Rock Spring Master Plan Public Hearing Draft: Worksession 2

Attachment 1 Rock Spring Master Plan: Summary of Written Public Hearing Testimony

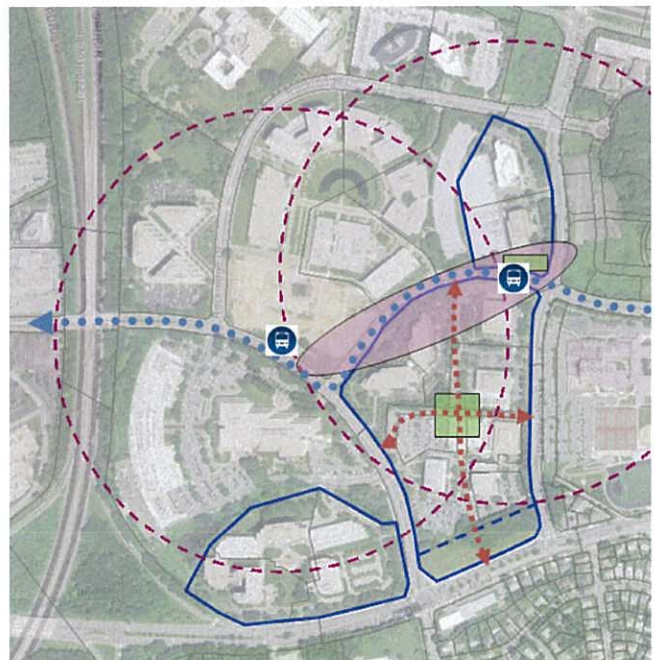
densities should be increased to a FAR 2.0 to incentivize a redevelopment with C 1.5 & R 1.5.

- Existing Zoning: NR-0.75 H-45
- Staff Recommendation: CRT-1.25 C-0.75 R-0.75 H-75
- Our Proposal: CRT-2.0 C-1.5 R-1.5 H-80

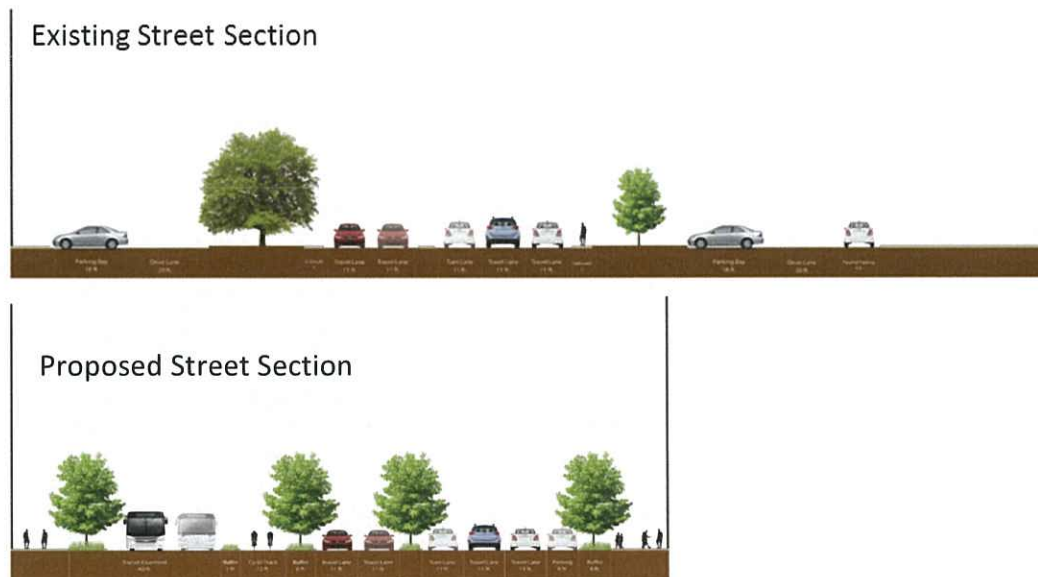
Because the EOF zones do not encourage this complete approach to a main-street, mixed-use vision, we are recommending Commercial Residential zones with varied heights based on individual site characteristics. Densities increased to a 2.5 FAR will provide the incentive necessary to redevelop these properties at the core. Greater heights at the center (equal to Rock Spring Centre) could then step to 110’ along Democracy Boulevard. These densities and heights are appropriate and

- Rockledge Executive Plaza
(Rockledge Executive Plaza One and Two)
 - Existing Zoning EOF-1.0 H-100
 - Staff Recommendation EOF-1.5 H-100
 - Our Proposal CR-2.5 C-2.0 R-2.0 H-275
- Rock Spring North
(Bedford Building; Westmoreland Building; Rock Spring Plaza 1 & 2)
 - Existing Zoning EOF-1.0 to 1.5 H-100
 - Staff Recommendation EOF-1.5 H-100
 - Our Proposal CR-2.5-C-2.0 R-2.0 H-225
- Rock Spring South
(Johns Hopkins Medical Building, approved Lincoln Building, Camalier and Champlain Buildings).
 - Existing Zoning EOF-1.0 H-100
 - Staff Recommendation EOF-1.5 H-100
 - Our Proposal CR-2.5 C-2.0 R-2.0 H-150
- Democracy Plaza
(One Democracy Plaza and Two Democracy Plaza; Marriott Suites Hotel)
 - Existing Zoning EOF-1.0 H-110
 - Staff Recommendation EOF-1.5 H-110
 - Our Proposal CR-2.5 C-2.0 R-2.0 H-150⁶
